# **IQRPE Design Assessment Report for IDF Leachate Tank Domes**

**Independent Qualified Registered Professional Engineer  
Design Assessment Report  
For  
Integrated Disposal Facility (IDF) Leachate Tank Domes**

**IQRPE Design Assessment Report  
No. DA-332610-02  
Rev. 2**

Meier Project No. 20-8692  
DGR Construction Contract No. 332610  
CPCCo Contract No. 72435

**Figure 5: Braced Frame Plan (H-2-837973, Sheet 2)**

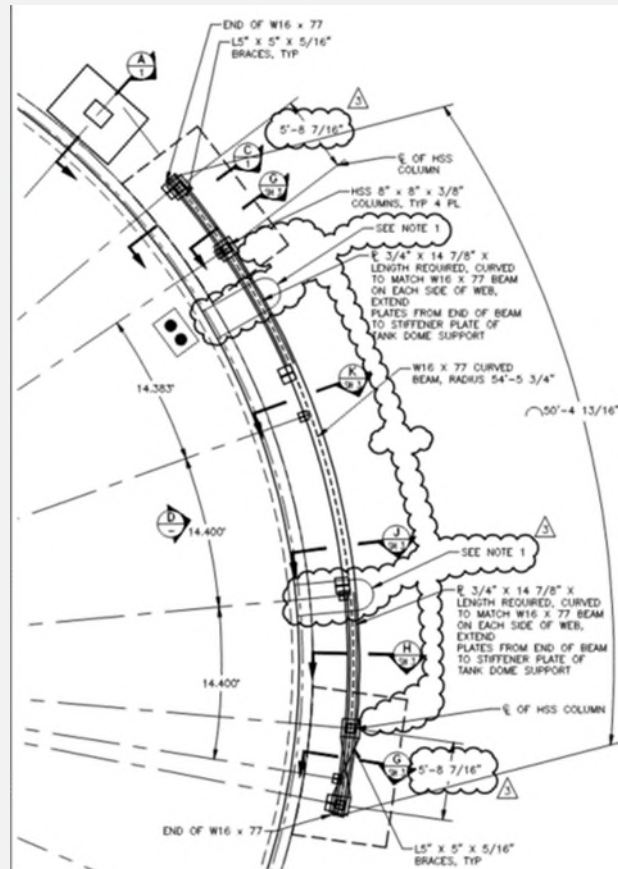
The dome cover braced frame support as shown in Figure 5 and Figure 6 was designed in CHPRC-04065 utilizing the reactions provided by the Aluminum Dome Cover Vendor. This braced frame serves two (2) purposes. The first is to allow a larger section of tank wall access without interior columns. The other is to prevent torsional rotation of the dome cover. In calculation CHPRC-04065, the reactions due to wind on the dome cover were adjusted to the required 110 mph wind speed instead of designing the support structure for the 120 mph wind speed utilized in the Aluminum Dome Cover Vendor calculations.

**Figure 7: Geo-Dome Column Modification (E040, Sheet 2)**

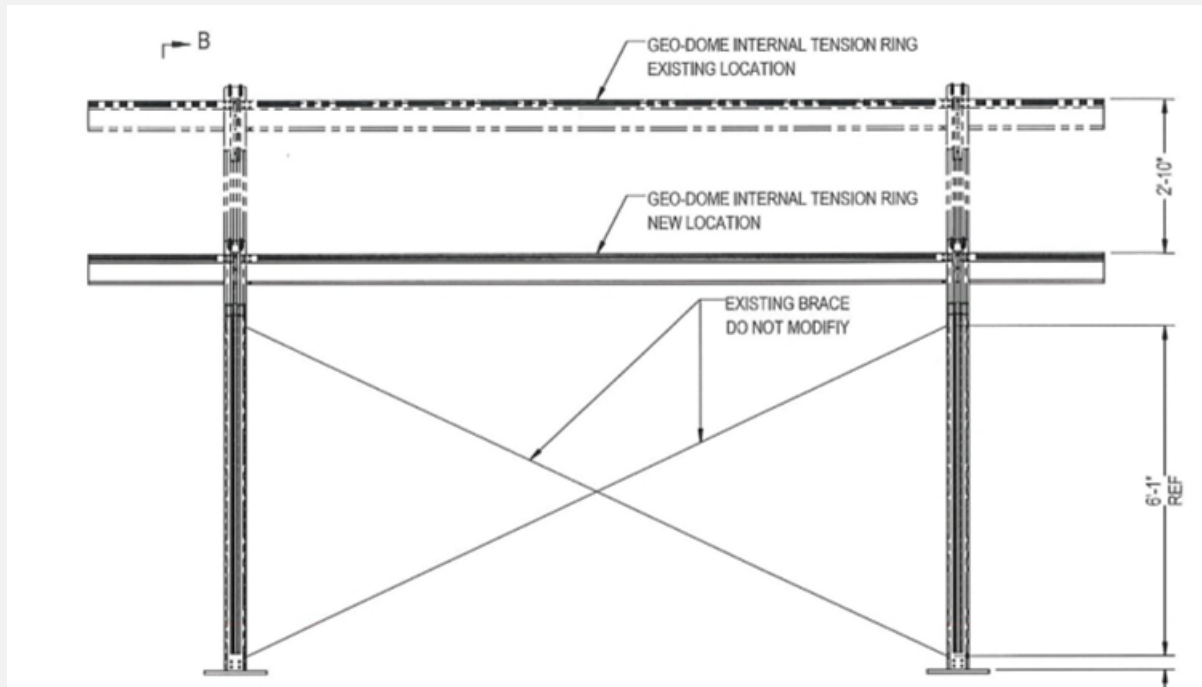
In addition to the structural steel braced frame support designed in CHPRC-04065, the dome cover has bracing between the legs provided by the dome vendor as shown in Figure 7.

**Figure 9: IDF Leachate Tank Cover Post Foundation (H-2-837973, Sheet 1)**

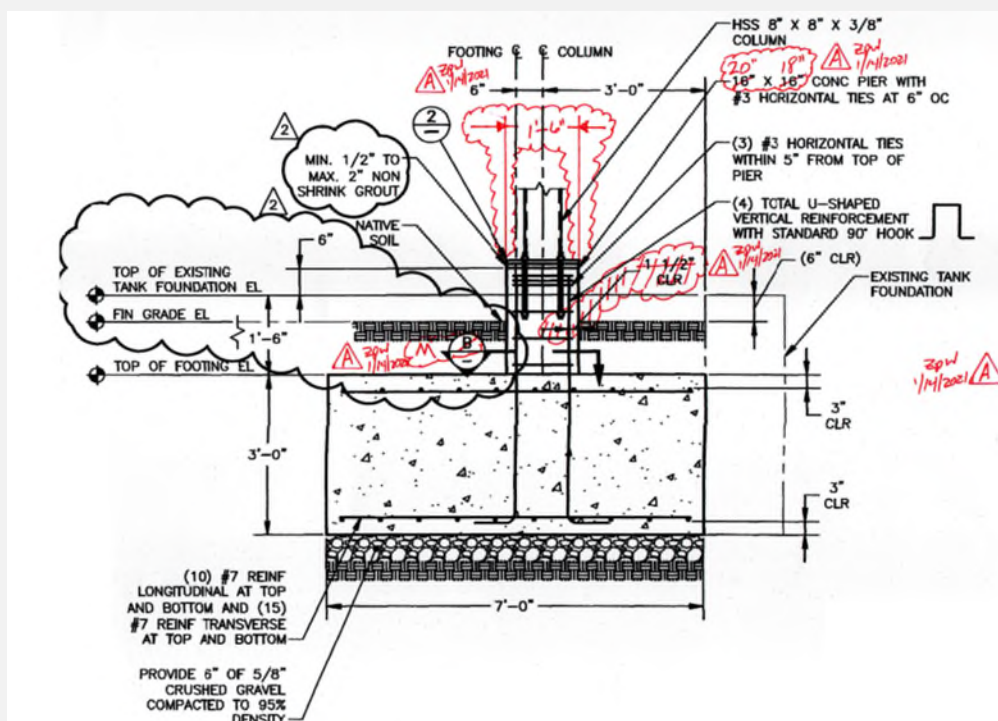
Per the design documents, the dome cover to be installed over the tank is supported at the foundation by pad footings and combined footings. The combined footings are 36" thick and the bottom of the new footing is to match the bottom of the existing ring foundation (H-2-837973, Sheet 1). Provided the tanks are empty at the time of placement of the new footings, and adequate re-compaction takes place, this should not pose any issues.
